MANUFACTURERS' RECEIVER TROUBLE CURES

VOLUME 3

A RIDER Publication

Fig. 1 — Magnavox

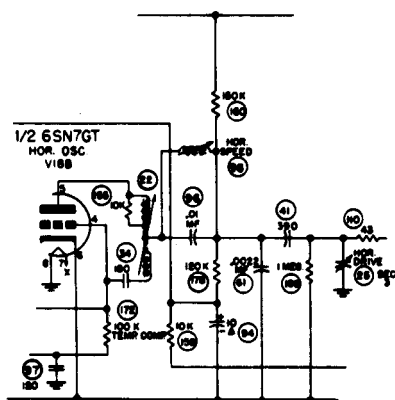
MAGNAVOX Chassis CT214
Improved horizontal stability
 (see Fig. 1).

An iron-slug speed coil (part No. 360346G1) as horizontal-oscillator frequency control is used in later production runs of the above chassis instead of the 120- μmf unit originally employed. Should it be desired to install this unit for improved stability of horizontal deflection, instructions outlined below should be followed:

1. Remove fixed capacitor *C33* (connected to pin 3 of sync clipper) and replace with mica capacitor 180 μmf , 10%, 500 volts (part No. 250159G85). Note: The capacitor which is removed may be used in step 3 below.

2. Remove horizontal speed capacitor. This will be the center capacitor of the three-gang trimmer *C25*.

6. Connect one side of coil to 2nd lug from the end of strip nearest horizontal-linearity coil *L13*. Remove resistor *R155* (10,000 ohms) and retain for use in step 8.

Fig. 2 — Majestic

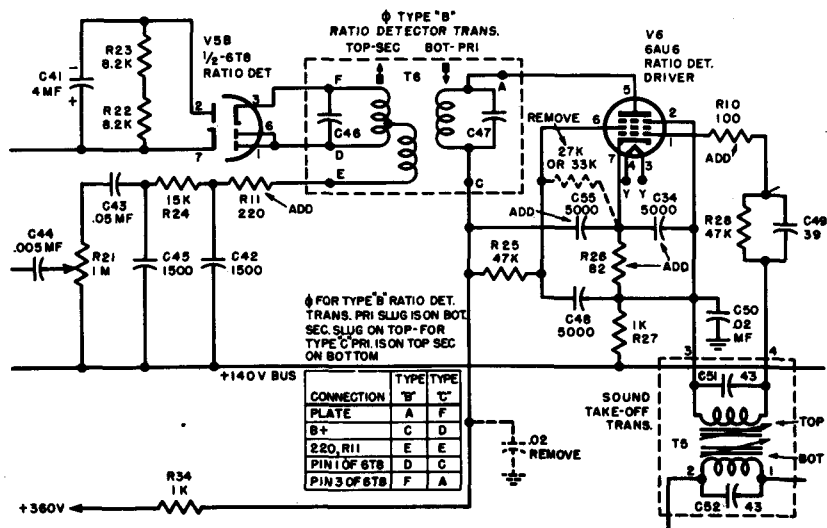
1. Remove the .02- μ f, 400-volt paper capacitor (6AU6 plate decoupling at junction of 1-k (*R34*) and 47-k (*R25*) resistors, located at a

terminal of the ratio-detector transformer).

2. Remove the 6AU6 screen bleeder resistor (located at 6AU6 pins 6 and 7). This resistor is 33 k on 94 series and 27 k on 97 and 98 series receivers.

7. Remove from 6AU6 pin 1 the leads of 47-k resistor (R28) and 39- $\mu\mu\text{f}$ capacitor (C49) and insert from that junction (R28 and C49) a 100-ohm, $\frac{1}{2}$ -watt resistor (R10) to 6AU6 pin 1.

8. Remove from a terminal on the ratio-detector transformer the leads of 15-k resistor (R24) and 1,500- $\mu\mu\text{f}$ capacitor (C42), and insert from that junction (R24) and (C42) a 220-ohm, $\frac{1}{2}$ -watt resistor (R11) to the same terminal on the ratio-detector transformer.

9. Remove jumpers between terminals 5 and 6 and between terminals 6 and 7 of the 6T8 (V5). Remove the leads from 6T8 pin 6 and reconnect to 6T8 pin 7. Insert jumper between 6T8 pins 5 and 7. Insert jumper with spaghetti between 6T8 pins 6 and 1.

Fig. 3 — Majestic

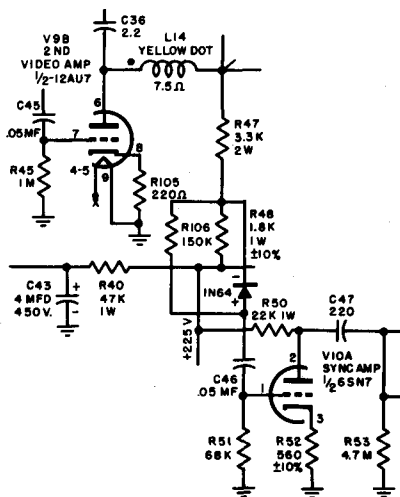
MAJESTIC Chassis 99 through 103, 105
Improved sync clipping and better horizontal hold
(see Fig. 3).

A crystal diode 1N64, is connected in series with the sync take-off lead to provide additional clipping action. The value of *R51* (grid resistor of sync amplifier) is changed from 1 meg to 68,000 ohms.

Also, in order to improve horizontal holding ability, *R106* (150-k resistor) is added across the 1N64 crystal.

A partial schematic diagram showing these changes as well as the change described under "Increasing sync amplitude" for these same chassis, is shown here.

Fig. 4 — Meck

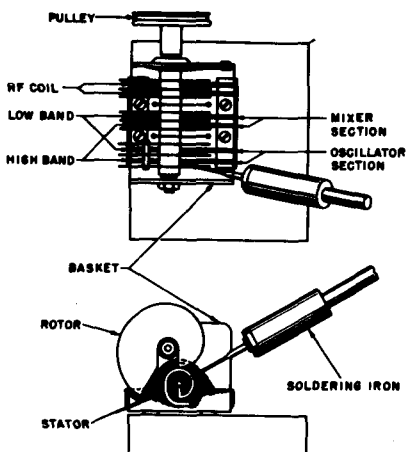
MECK Chassis with
TT-10006 tuner
Intermittent or low-sensitivity tuners (see Fig. 4).

The TT-10006 tuner depends upon a variable inductance for its correct operation. This variable inductance unit consists of the carriage, mounted on top of the tuner, the stator coil assembly, and the rotor plate assembly. The carriage is the U-shaped bracket which holds the copper rotor plate assembly and the rotor shaft. The stator coil assembly consists of six printed coils which are molded on linen bakelite strips. The center of each printed coil is terminated in a tinned eyelet which extends through the linen bakelite.

turned down and filed into the shape of a small screw driver blade. Run one-quarter inch of solder which has a very small diameter down the screwdriver blade to the eyelet. This operation should be done with the rotor blades turned out as far as possible, and should be necessary only for the oscillator and mixer coils as shown in the figure. It is unnecessary to remove the tuner from the television chassis to carry out this soldering operation; however, with the round-tube models, it may be necessary to bend the point of the iron at right angles in order to place the tip of the iron in the correct position.

Fig. 7 — Montgomery Ward

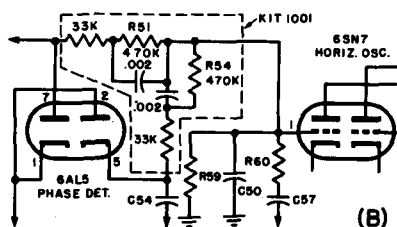
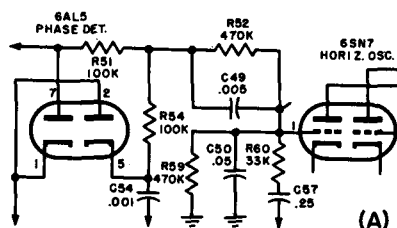
To correct this condition changes are made in the 6AL5 phase de-

tector circuit. Chassis already having these changes incorporated are stamped "YB" on the rear flange. Sets without these changes are stamped "YA." Part (A) of the figure shows the original (YA) 6AL5 circuit and part (B) shows the revised (YB) circuit. All parts necessary to make this change are supplied pre-connected in kit form. The component parts in this kit are listed below:

LAYOUT USED WITH NEW TRANSFORMER

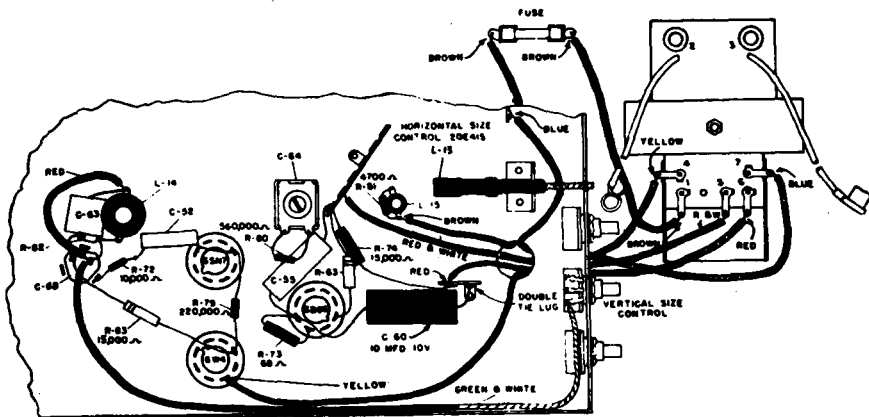
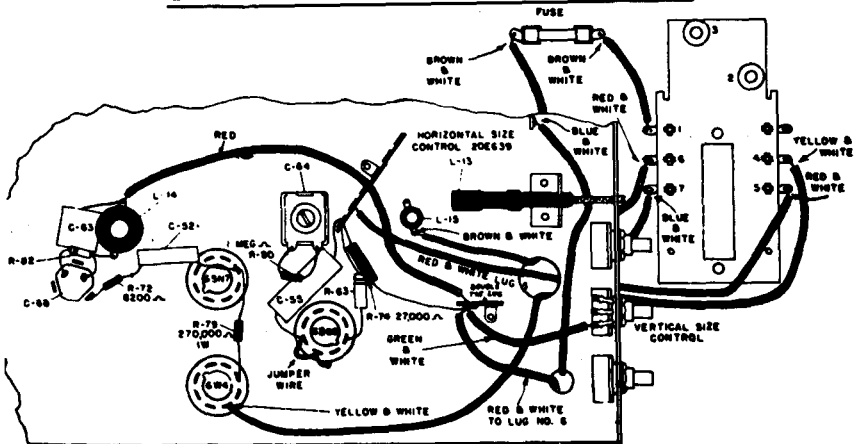
Due to changes in construction of the flyback transformer it is necessary to revise the circuit slightly and change several components for proper operation of the set when replacing the 22E57 transformers (see circuit and wiring changes). To do this proceed as follows:

1. Replace the horizontal-output and h-v transformer with new transformer and connect as shown.

2. Change the 10,000-ohm, $\frac{1}{2}$ -watt peaking resistor *R72*, located in the 6SN7 horizontal-oscillator output circuit, with an 8,200-ohm, $\frac{1}{2}$ -watt resistor, part No. 27E822-2.

4. Change the 15,000-ohm, 2-watt resistor *R74* (some sets used two 7,500-ohm, 1-watt resistors in series) in the screen circuit of the 6BG6G horizontal-output tube to a 27,000-ohm, 2-watt resistor, part No. 27E273-5.

5. Change the 560,000-ohm, $\frac{1}{2}$ -watt resistor *R80* across the drive control in the grid circuit of the 6BG6G horizontal-output tube to a 1-meg, $\frac{1}{2}$ -watt resistor, part No. 27E105-2.

6. Disconnect the 100- μ f, 10-volt bypass capacitor *C60* and the 68-ohm, $\frac{1}{2}$ -watt resistor *R73* in the cathode circuit of the 6BG6G horizontal-output tube and remove.

8. Disconnect the 4,700-ohm resistor *R81* located across the horizontal-linearity coil *L15* and remove.

9. Disconnect the 15,000-ohm, 5-watt resistor *R83* (some sets used four 15,000-ohm, 1-watt resistors in series-parallel) and remove.

10. Clip out the lead between the horizontal-lock coil *L14* and electrolytic capacitor *C68* and reconnect the horizontal-lock coil with a longer length of wire to the B+ lug on the double-tie lug located adjacent to the vertical-size control.

12. Replace the horizontal-size control (part No. 20E415) coil *L13* with a new coil, part No. 20E639.

Fig. 9 — Montgomery Ward

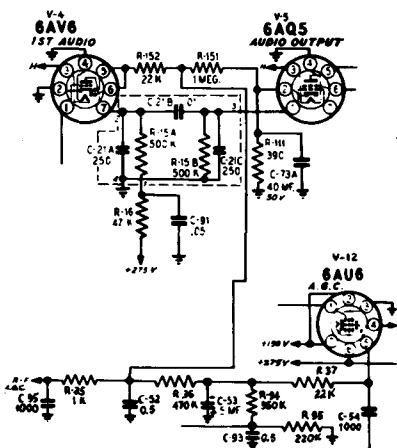
Near the end of production a change was made in the agc circuit to improve the signal-to-noise ratio for fringe-area operation. This

change is incorporated in the schematic diagram shown here.

If it is desired to incorporate this circuit change in earlier production (models 05WG-3030C, 05WG-3036A & B, or 05WG-3039A & B) the changes in the table should be made.

Fig. 10 — Montgomery Ward

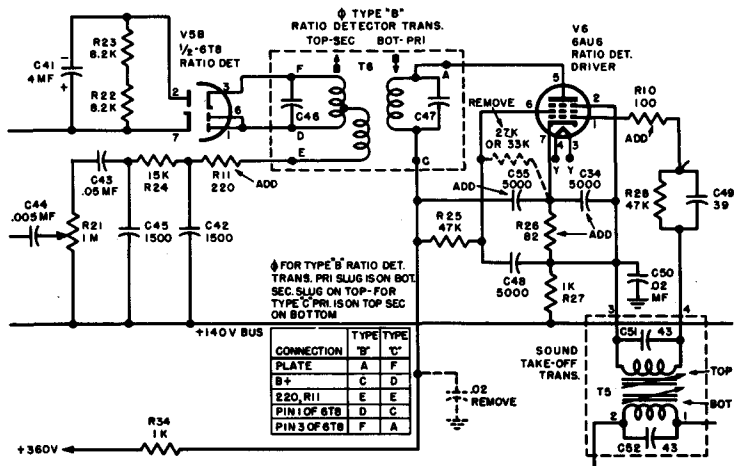
2. Remove the 33-k 6AU6 screen-bleeder resistor (located at 6AU6 pins 6 and 7).

7. Remove from 6AU6 pin 1 the leads of 47-k resistor (*R28*) and 39- μ f capacitor (*C49*) and insert from that junction (*R28* and *C49*) a 100-ohm, $\frac{1}{2}$ -watt resistor (*R10*) to 6AU6 pin 1.

8. Remove from a terminal on the ratio-detector transformer the lead of 15-k resistor ($R24$) and 1,500- μ mf capacitor ($C42$) and insert from that junction ($R24$ and $C42$) a 220-ohm, $\frac{1}{2}$ -watt resistor ($R11$) to the same terminal on the ratio-detector transformer.

Fig. 11 — Montgomery Ward

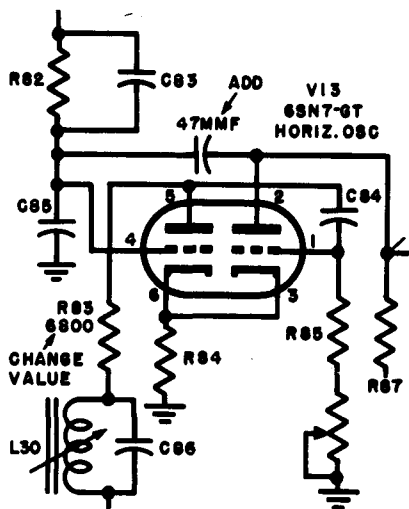
Models 84HA-3010 A, B, C
Improved horizontal sync
(see Fig. 11).

To improve the horizontal sync, proceed as follows:

Fig. 13 — Montgomery Ward

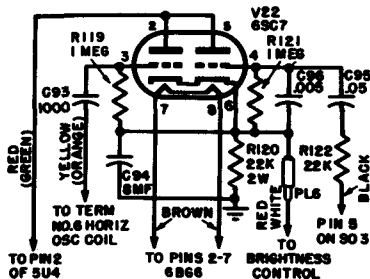
After these sets reached the field, a picture-tube protective circuit kit was made available for installation. The purpose of this circuit is to cut off the intense electron beam in the picture tube in event of failure in either the horizontal- or vertical-sweep circuits. This prevents burning a line into the face of the picture tube and rendering the tube useless.

Fig. 14 — Montgomery Ward

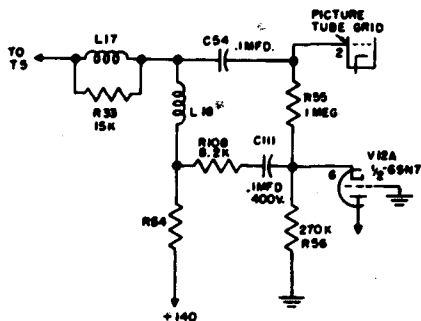
Picture twist at high brightness settings (see Fig. 14).

If picture twist occurs mainly upon advancing the brightness control, the d-c restorer circuit should be altered as follows:

Fig. 17 — Motorola

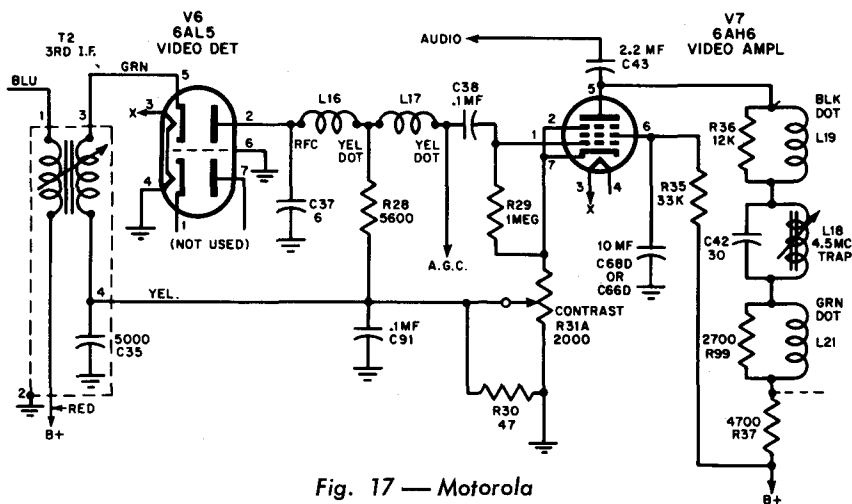
MOTOROLA Chassis TS-89, TS-95
Improved compensation
(see Fig. 17).

An improvement in picture quality is achieved with a change in compensating coils. *L17* (in video-detector circuit) is changed from a red-dot coil to a yellow-dot coil; *L19* (in plate circuit of video amplifier) is changed from a red-dot coil to a black-dot coil; and *L21* (in plate circuit of video amplifier) is changed from a green-black dot coil to a green-dot coil. With this change in compensation, the R-C network on the tapped contrast control, *R31A*, is eliminated. Later production runs already include this modification.

Fig. 22 — Motorola

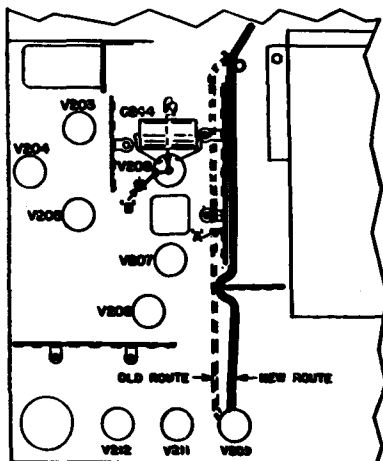
1. Replace the shielded contrast lead with an unshielded lead.
2. The shielded volume - control lead is originally routed between the terminal strip (A) and the audio i-f strip. Reroute this lead to the other side of the terminal strip to minimize the 4.5-mc pickup in the lead.
3. The ground lead from the center pin of the ratio-detector socket (V208, 6AL5) is originally dressed

over the 10- μ f electrolytic (C244) to a chassis ground kick-out. Move the lead from this kick-out to the kick-out near the tube socket on the video i-f side (B).

Fig. 23 — Motorola

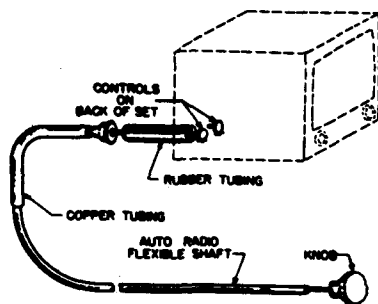
The copper tubing is helpful in controlling the degree of bend to

prevent binding. The short length of rubber tubing is cut from windshield-wiper hose.

Fig. 29 — Muntz

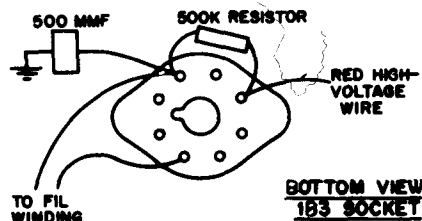
MUNTZ Chassis M169
Frying sound at low picture-control settings (see Fig. 29).

A frying sound from the rear of the cabinet that occurs at low settings of the picture control may be caused by a slight corona condition from the high-voltage leads to ground beneath the 1B3 tube socket. To remedy, wire the 1B3 tube socket as shown in the figure.

Fig. 31 — National

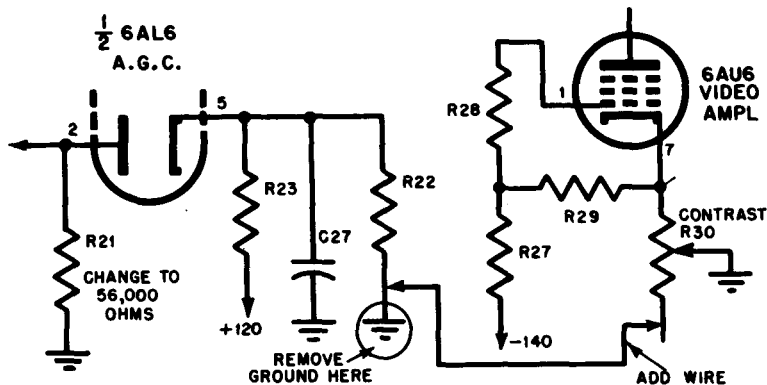
2. Change *R21* (from pin 2 of 6AL5 to ground) from 22,000 to 56,000 ohms.

3. Remove ground end of 1,000-ohm resistor on pin 5 of 6AL5 and run a wire from it to unused end of contrast control, as shown. It may be necessary to add a lug for support of the resistor in its new position.

Fig. 32 — National

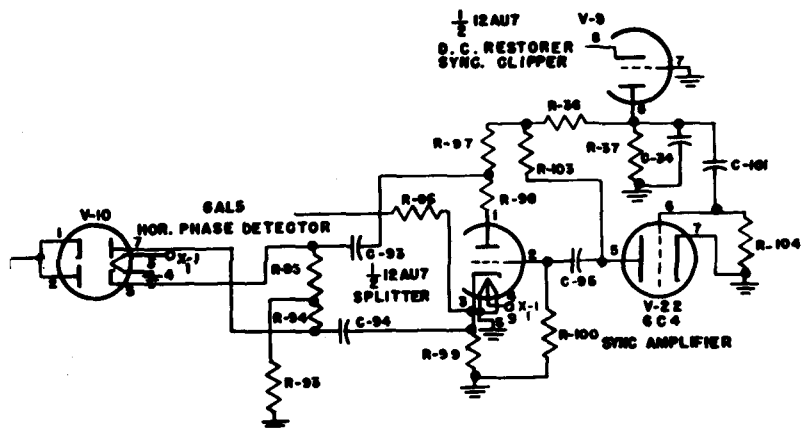
The affected portion of the schematic diagram is shown in the figure. Note the phase reversal at the horizontal phase detector tube *V10*.

Fig. 33—Pacific Mercury

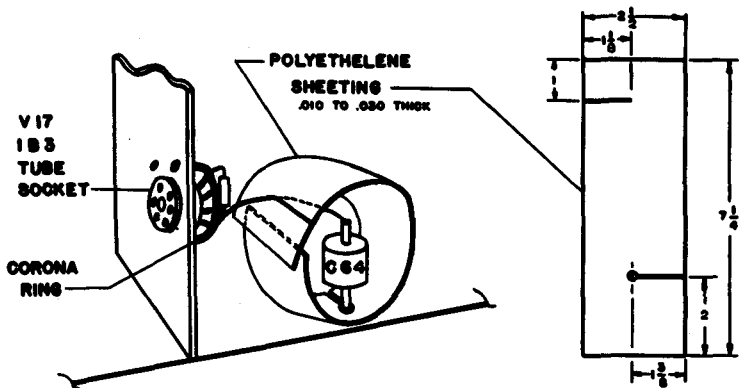
3. Change *R82*, 120,000-ohm, 1-watt resistor, to 68,000 ohms, 1 watt. This resistor is at terminal C of the horizontal-oscillator coil.

Fig. 34—Pacific Mercury

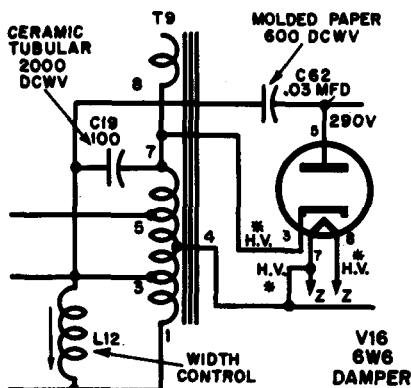
PACIFIC MERCURY All models
Horizontal-sync instability
 (see Fig. 34).

Horizontal-sync instability and the appearance of dark irregular patches in the picture may indicate failure of the 100- μmf capacitor, *C19*, in the horizontal-output circuit. This capacitor, with a rating of 1,500 volts, has shown a tendency to arc internally and exhibit corona. Therefore this mica capacitor is being replaced in production with a 100- μmf ceramic tubular type, having a rating of 2,000 volts. Servicemen should replace *C19* with a similar capacitor, if the above symptoms appear in a receiver, even though the mica capacitor seems to be good, since the internal arcing is very difficult to detect.

Fig. 35 — Packard Bell

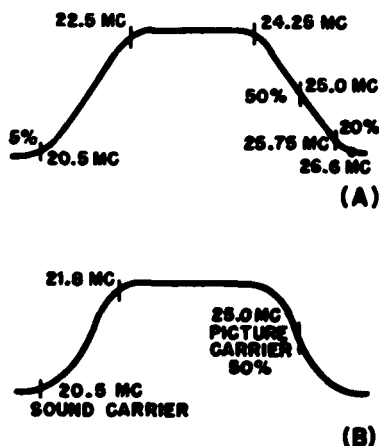
Alignment in fringe areas
 (see Fig. 35).

In order to gain the added sensitivity necessary in some fringe areas, it is recommended that the picture i.f. be aligned as shown in part (A) of the figure. Normal response is shown in part (B).

Fig. 36 — Packard Bell

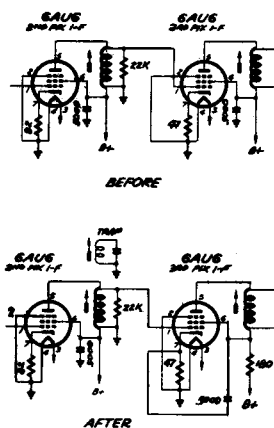
Improved sensitivity in fringe areas (see Fig. 36).

The circuit shown in the figure will provide a marked improvement in overall i-f gain and stability. The

Fig. 42 — Philco

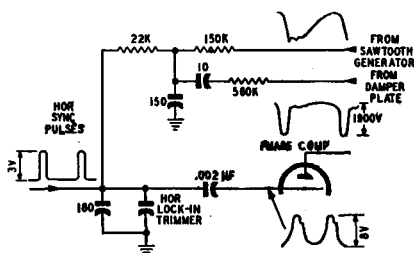
PHILCO Models 50-1403, 50-1630
Horizontal foldover
(see Fig. 42).

The following circuit change may be added to the above models using the phase-comparer circuit if horizontal foldover is present, and is used in all models built after and including the code 125 of the 1403 series, as well as the code 122 of the 1630.

Fig. 45 — Philco

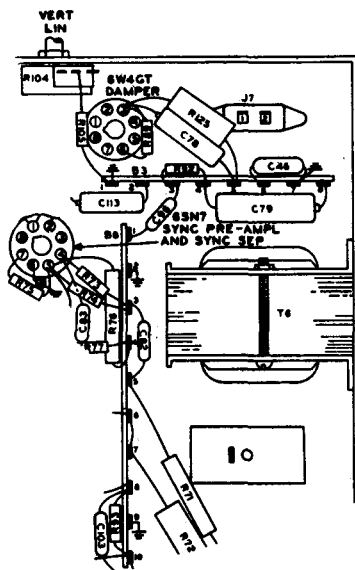
Horizontal tear at the top of the picture may be caused by a horizontal-damper lead radiating energy

into the sync-separator circuit. The effect of this radiation may be reduced by re-dressing these leads as follows:

Fig. 46 — Philco

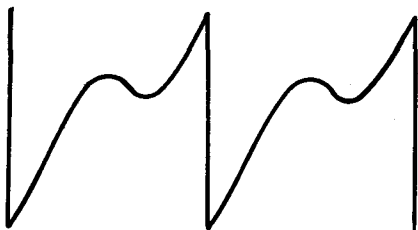
PHILCO Model 50-T1400
Horizontal-oscillator squeal
(see Fig. 46).

Starting with the production of code 125 of the above television receivers, a new type of horizontal-oscillator circuit was used in all sets. This particular circuit incorporates a stabilizing section in the blocking oscillator. When the horizontal oscillator is improperly adjusted, in many cases a peculiar shrill sound of about 1,000 cycles per second is heard, and an accompanying out-of-sync condition is noted on the pic-
